# AMENDMENT NO.3 TO KINGSFORD

## BULLSBROOK CENTRAL LOCAL STRUCTURE PLAN

Amendment No. 3 to the Kingsford Central Local Structure Plan

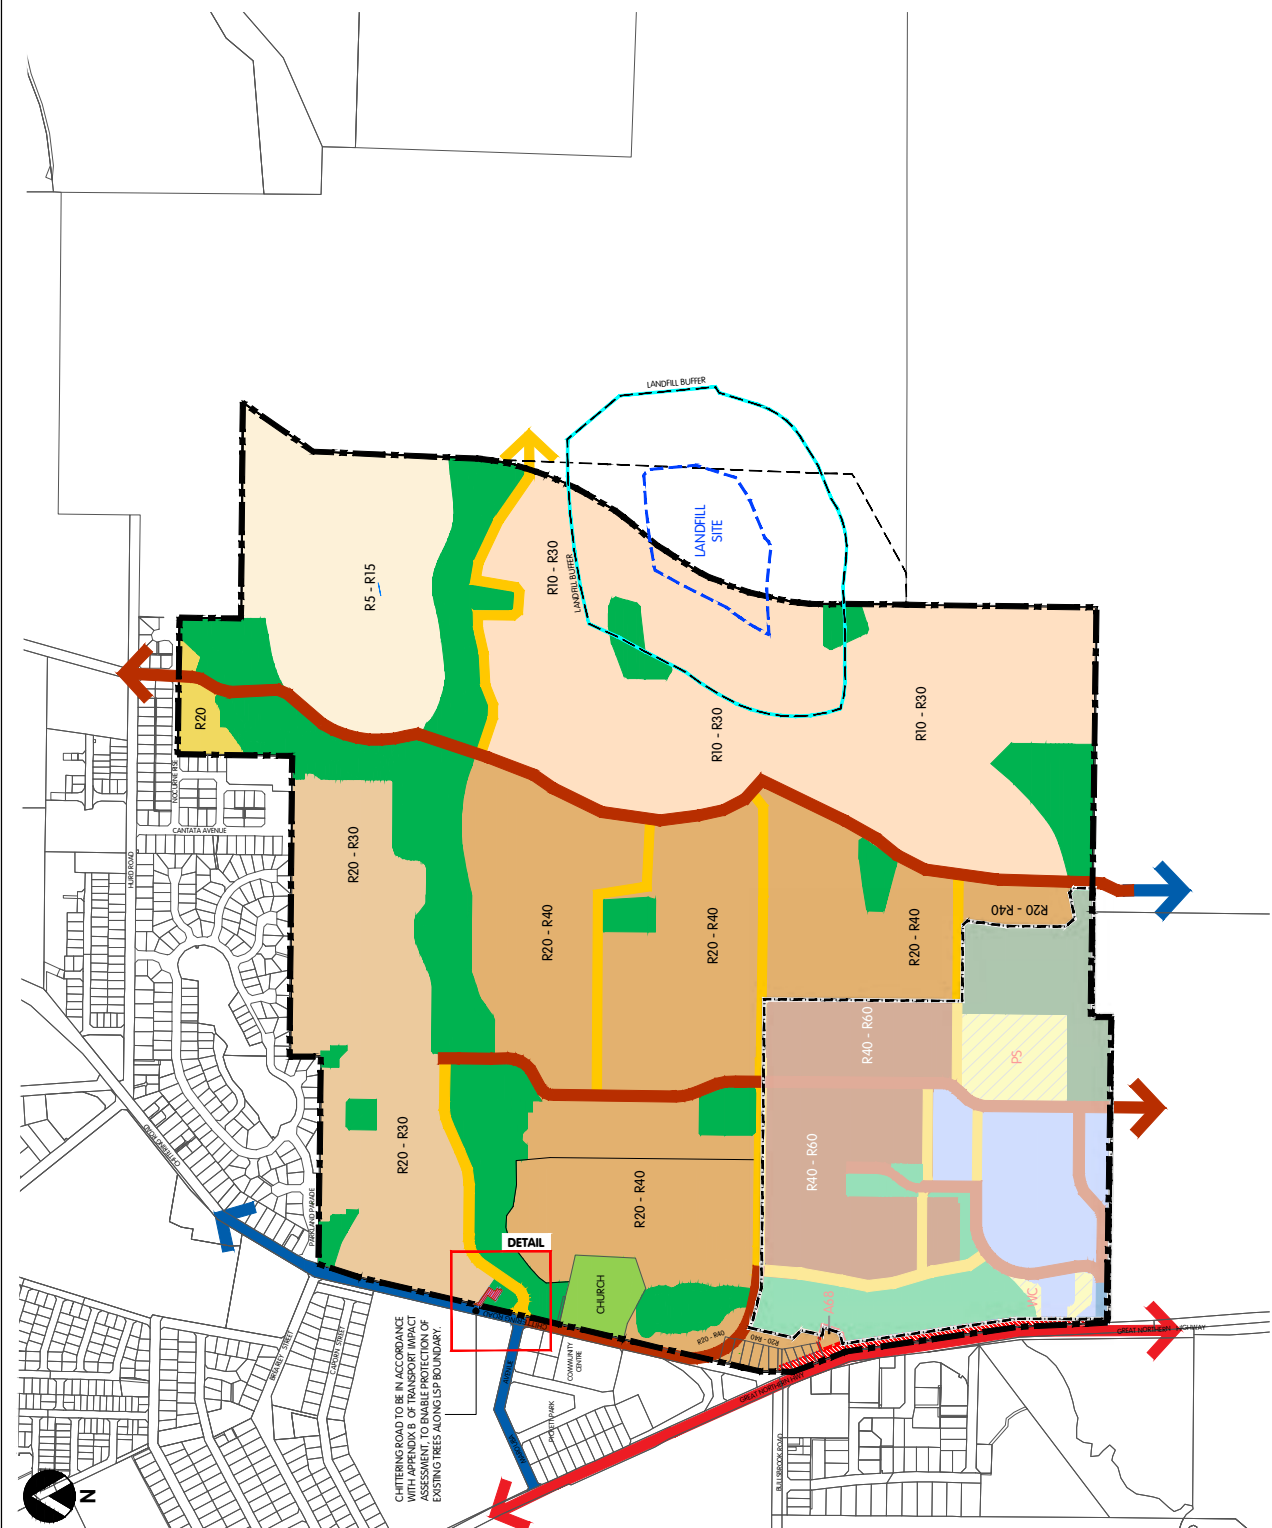
Information provided to DWER to support the application for a Works Approval to undertake capping of the landfill was reviewed by the Contaminated Sites branch within the Department. This review resulted in the classification of the portion of Lot 903 (on Deposited Plan 424344) pursuant to the provisions of the Contaminated Sites Act 2003 as 'Possibly contaminated - investigation required'. This classification applies to the premises footprint and incorporates a buffer of at least 150m to the west of the facility footprint towards the areas undergoing residential development as part of the Kingsford estate. The current licence does not permit receipt of further waste at the facility, and as such the main source for any noise dust (key emissions risks identified by the EPA guidance statement), and/or odour, is no longer present outside the 150m buffer.

Kingsford Central  
Updated LSP Map

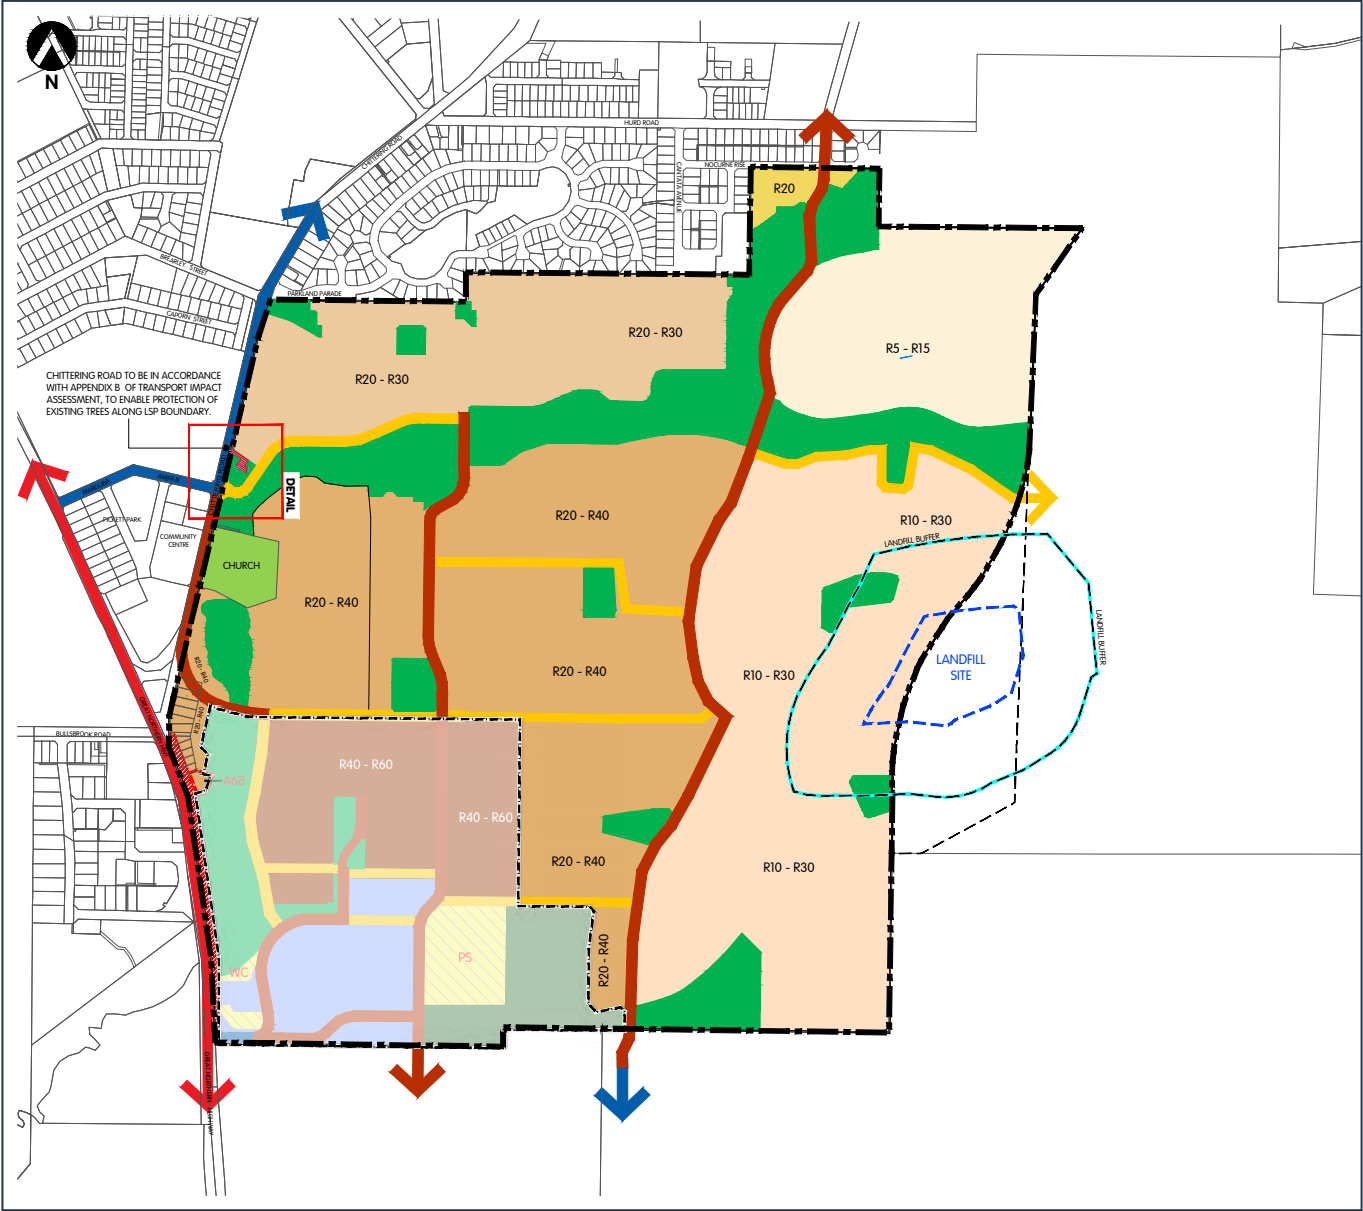
| Part     | Section                              | Proposed Modification                                                                                                                                                                                                                                                                                                                                                                                                                                                                                                                                                                                                                                                                                                                                                                                                                                                                                                                                                                                                                                                                                                                                                                                                                                                                                                                                                                                                                                                                                                                                                                                                                                                                                                                                                                                                                                             |
|----------|--------------------------------------|-------------------------------------------------------------------------------------------------------------------------------------------------------------------------------------------------------------------------------------------------------------------------------------------------------------------------------------------------------------------------------------------------------------------------------------------------------------------------------------------------------------------------------------------------------------------------------------------------------------------------------------------------------------------------------------------------------------------------------------------------------------------------------------------------------------------------------------------------------------------------------------------------------------------------------------------------------------------------------------------------------------------------------------------------------------------------------------------------------------------------------------------------------------------------------------------------------------------------------------------------------------------------------------------------------------------------------------------------------------------------------------------------------------------------------------------------------------------------------------------------------------------------------------------------------------------------------------------------------------------------------------------------------------------------------------------------------------------------------------------------------------------------------------------------------------------------------------------------------------------|
|          | Plan 1                               | Update Plan 1 to reflect modified Structure Plan map, including following specific modifications:<br><br>1. Reduced landfill buffer from 500m to 150m                                                                                                                                                                                                                                                                                                                                                                                                                                                                                                                                                                                                                                                                                                                                                                                                                                                                                                                                                                                                                                                                                                                                                                                                                                                                                                                                                                                                                                                                                                                                                                                                                                                                                                             |

Modification 1 is to Update Plan 1 to reflect a modified Structure Plan map, including the following specific modifications:

1. Change the buffer outline from a radius of 500m from the landfill facility to 150m.
